PUBLIC MEETING REPORT STRICKLAND ROAD PARK PHASE I

Date of Meeting: July 28, 2009, 7-8:30 PM Lake Lynn Community Center

The plans presented represent 30% construction design for Phase 1 of the design shown on the approved Master Plan. Construction is expected to start in March, with completion in late fall. This public meeting provides an opportunity for public comment on the proposed work. The Public Comment period extends till August 11. The plans and comments will be presented to the Parks Recreation and Greenways Advisory Board at their August 20 meeting.

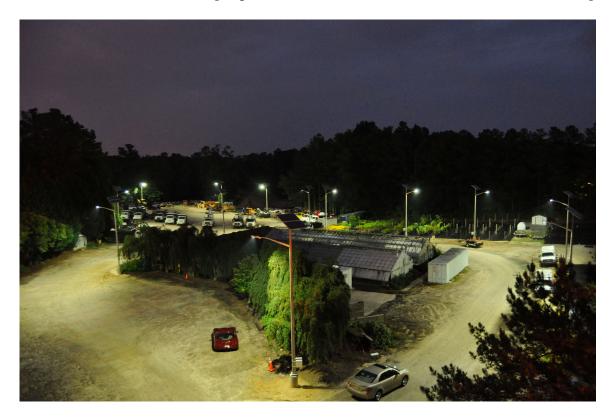
5. What will the lights look like? How tall are they? Will we be able to see them from our house? (Roundtree neighbor). Will they be on all night? Are there any installed elsewhere in town that we can look at?

Response: The lights will be similar to typical parking lot lights, probably about 30' tall. They are directed downward so should not provide much light out to the sides. They will be about 450'-550' from the nearest points on the property lines with relatively dense woods including pines between them and neighboring properties. You may be able to see a twinkle of light but not a bright beam. They will be on all night, controlled by a light sensor. This type of light is currently installed at the Parks Department's Marsh Creek Maintenance Facility, but this area is not easily accessible to the public. A photograph of these lights is included below. Note that there will only be two lights at Strickland Road Park, so the area will not be as bright as the site shown in this picture.
